# Comment i-31:

# Single PMD w/ optional RS-FEC

Yasuo Hidaka ([yasuo.hidaka@us.fujitsu.com](mailto:yasuo.hidaka@us.fujitsu.com))  
Fujitsu Laboratories of America, Inc.

Figure 73-11—Arbitration state diagram

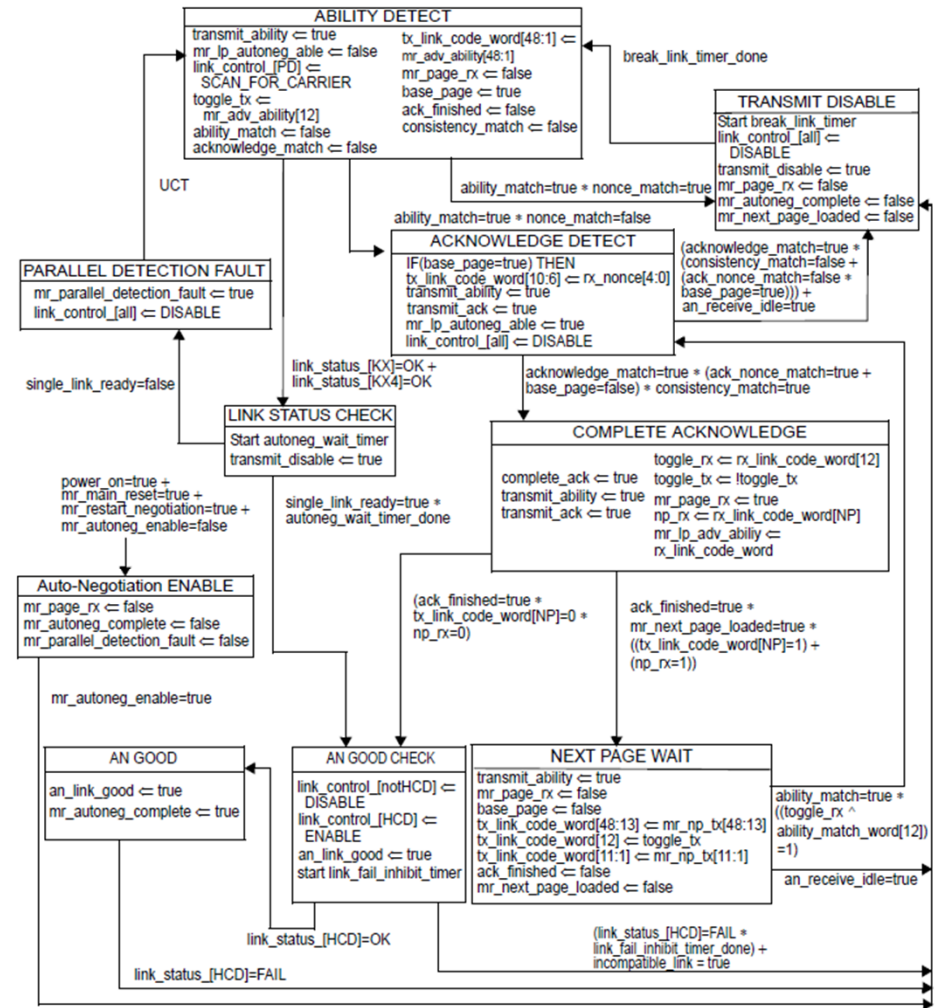
- AN in Clause 73 never fails due to 10G FEC-mode resolution
  - 10G FEC-mode resolution always succeeds
    - F0 : 10G FEC ability
    - F1 : 10G FEC requested
  - AN fails only if there is no HCD (Highest Common Denominator) of PMDs at two ends of the link

- With option 4, AN now may fail due to FEC-mode resolution
  - AN may fail if “RS-FEC required” cannot be satisfied
  - We may have to change AN state diagram shown on right
    - I do not want to do this. Anybody?
